Re: Johnson Stan Eagles Landing Highway 104 multi-family pre-app

PREAPPLICATION COMMENTS

Eagles Landing Apartments Site Design Review Application Response to Pre-Application Notes

EAGLES LANDING APARTMENTS

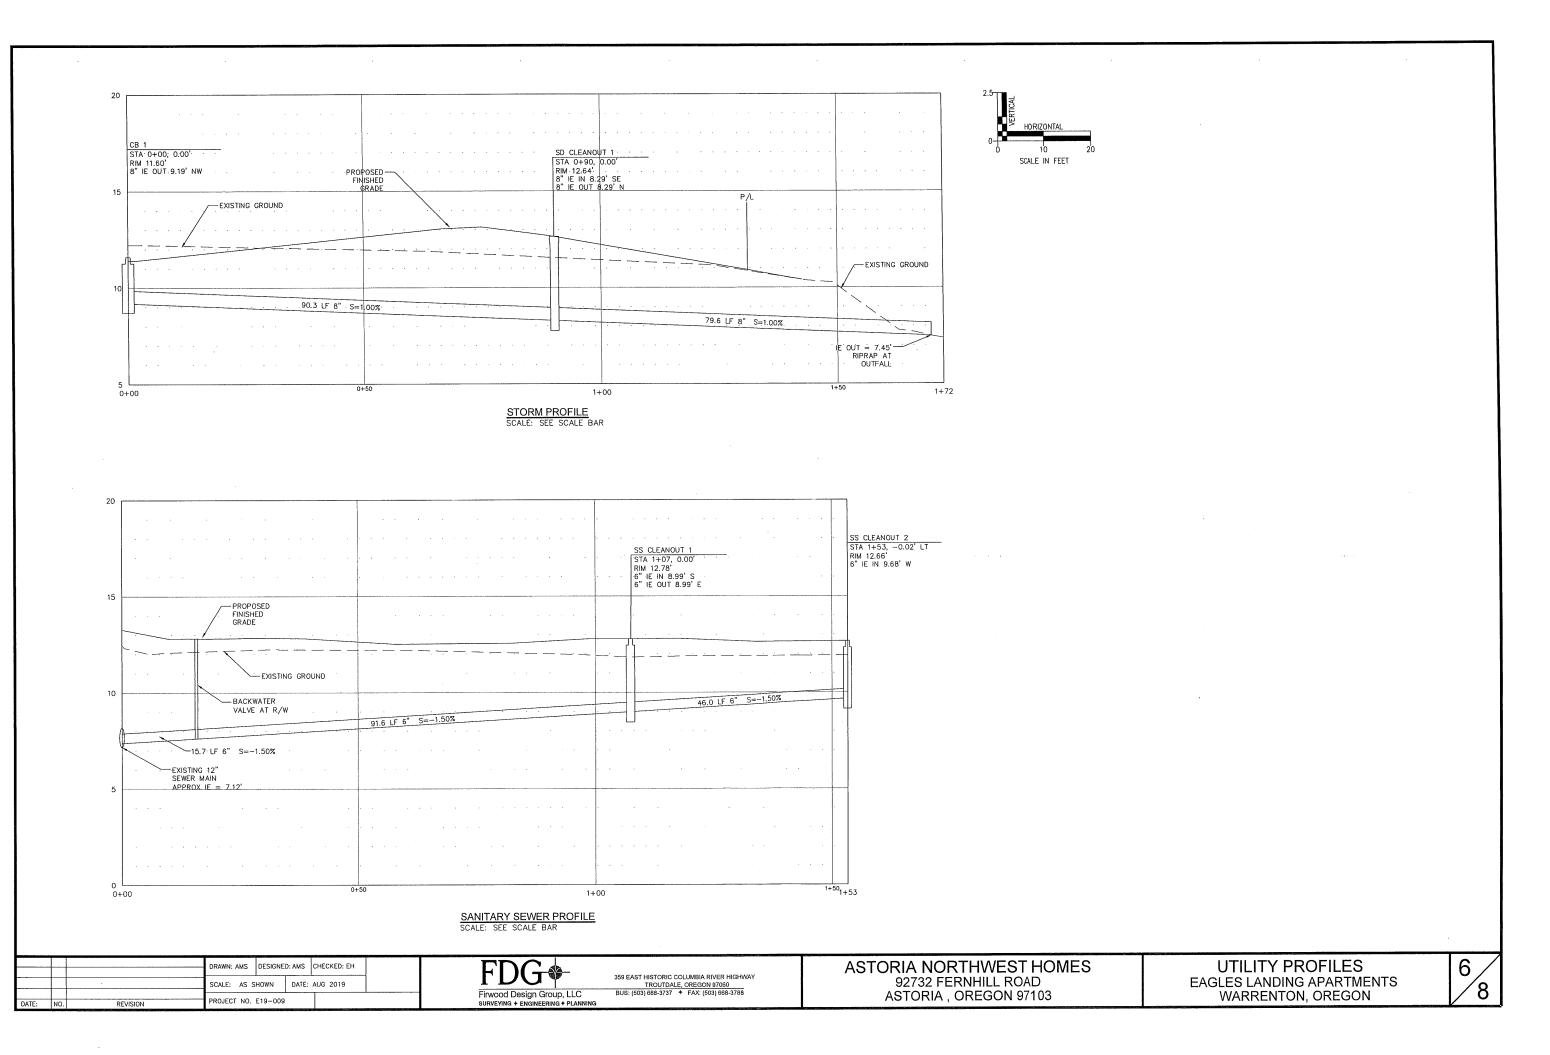
- 5- Sheet 4 Storm Profile indicates a storm water slope of .5%. This does not meet the requirements of OPSC 708.0 that stipulates a minimum slope of 2%. There has been no dialog requesting deviation from the OPSC requirements.

- 6- Sheet 4 Sanitary Sewer Profile indicates a slope of 1%. This does not meet the requirements of OPSC 708.0 that stipulates a minimum slope of 2%. There has been no dialog requesting deviation from the OPSC requirements.

- 7- Sheet 4 Sanitary Sewer Profile indicates a sewer pipe size of 6". Drain Fixture Unit calculations will be required at building permit submittal and documentation will be required to provide compliance with OPSC Table 7-5.

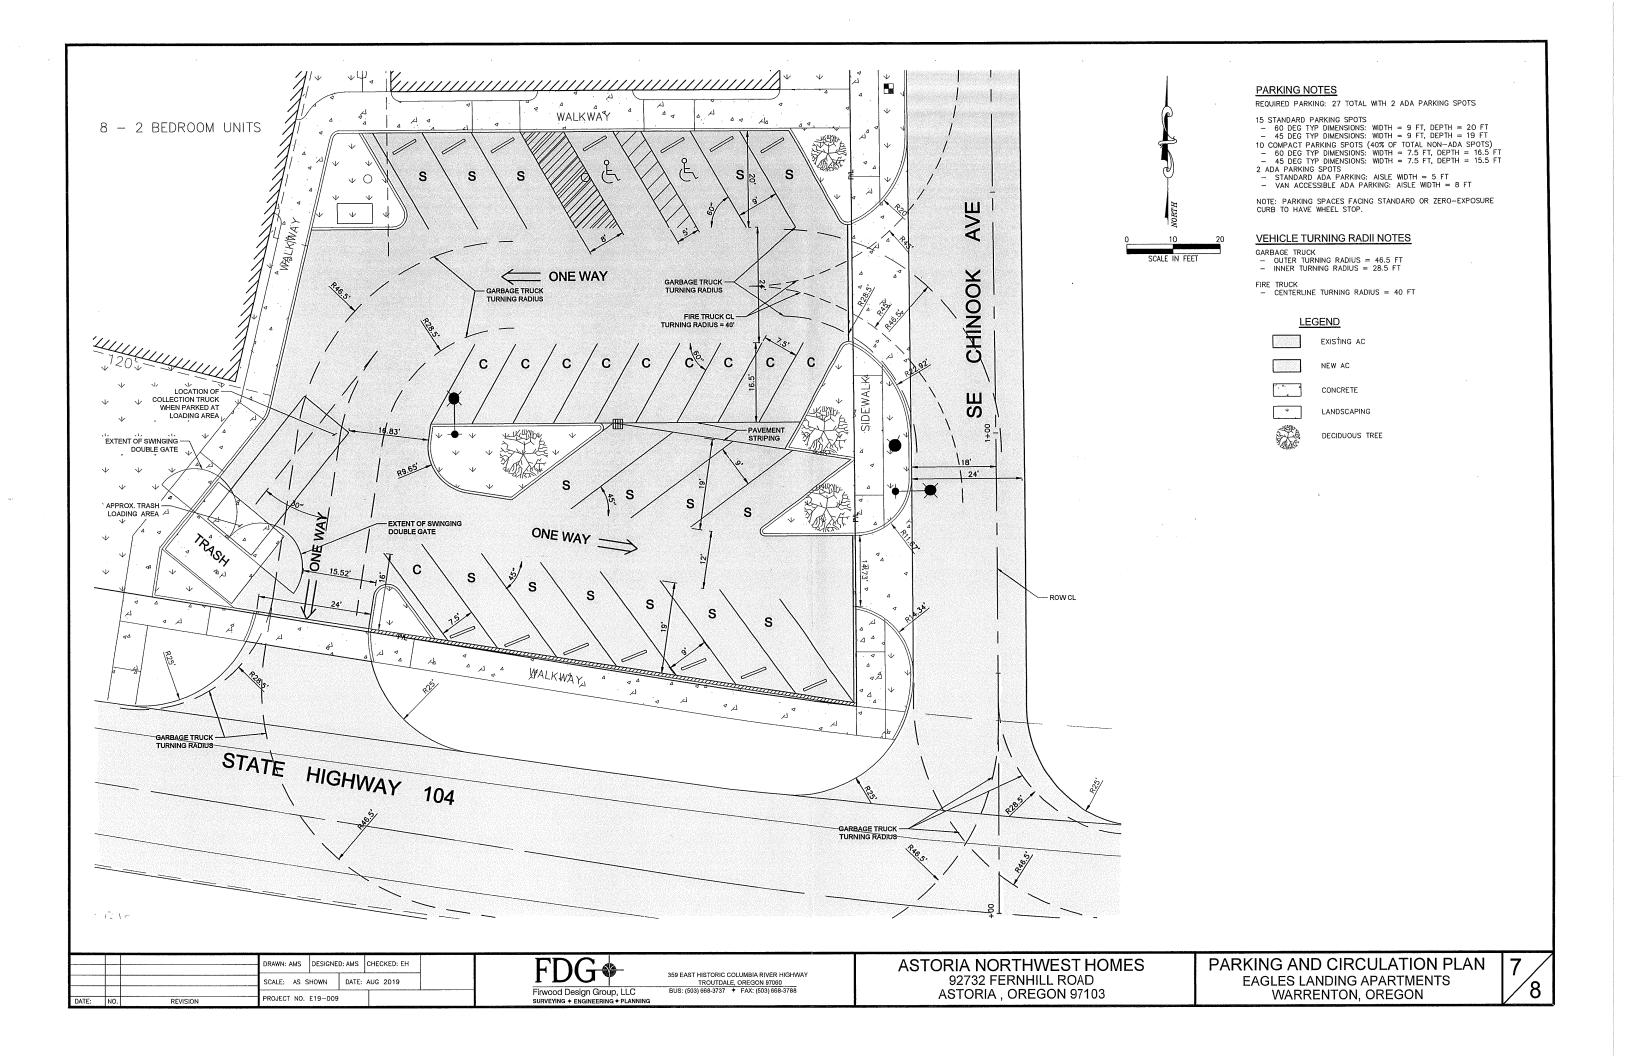
- 4 Provide location and dimensions of all parking and vehicle circulation areas (show striping for parking stalls and wheel stops, as applicable), and proposed paving materials. Provide wheel stops for head to head parking stalls.

Applicant response: Sheet 7 notes that there will be 27 total automobile parking spaces, including 2 ADA spaces and 10 compact spaces meeting the dimensional standards of WMC Table 16.128.030.C. Bicycle parking is proposed adjacent to the northern most building and will provide the requisite 4 spaces. The ingress drive aisle to SE Chinook Avenue will be 24 feet wide and continue southbound on the western side of the parking lot. The egress drive aisle to SE Chinook Avenue will be 12 feet wide, consistent with WMC Table 16.128.030.C. One outdoor pole light no higher than 25 feet is proposed in the landscape area in the center of the parking lot. One street light is proposed on SE Chinook Avenue.

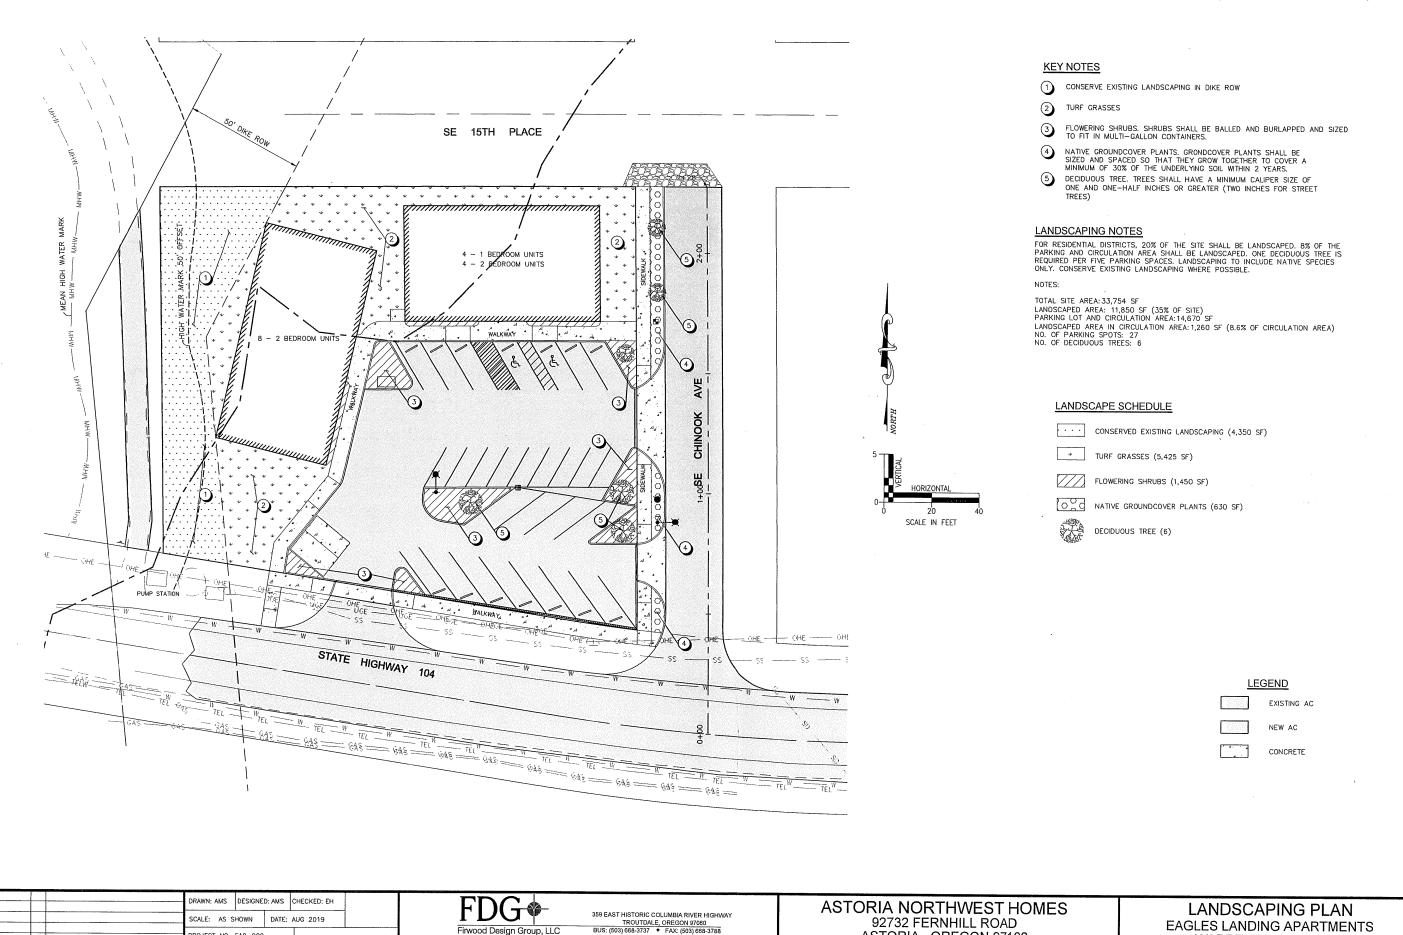
- 19 Provide landscape plan is required and shall comply with Chapter 16.124. The information required by this section has been provided on several other sheets. Show all required information on the landscape plan as well for context. Include plant species.

Applicant response: Sheet 8 shows the landscaping plan, which notes that 35 percent of the site will be landscaped. There is no hardscape feature proposed. Wheel stops will be placed in all parking places (See Sheet 7.) Six deciduous trees are shown on Sheet 8; however, two additional trees will be added to the parking lot area—a second tree in the western parking island on the center pod and behind the mail boxes in the northwest corn of the parking lot such that 6 trees will be in the 27-space parking lot.

- 2. Sheet 8 is the landscaping plan. Calculations are in the upper right corner and show the design exceeds the requirements for residential landscaping of 20 percent generally (WMC 16.124.070.C.1) and meeting the standard for parking areas (WMC 16.124.070.E.2.)
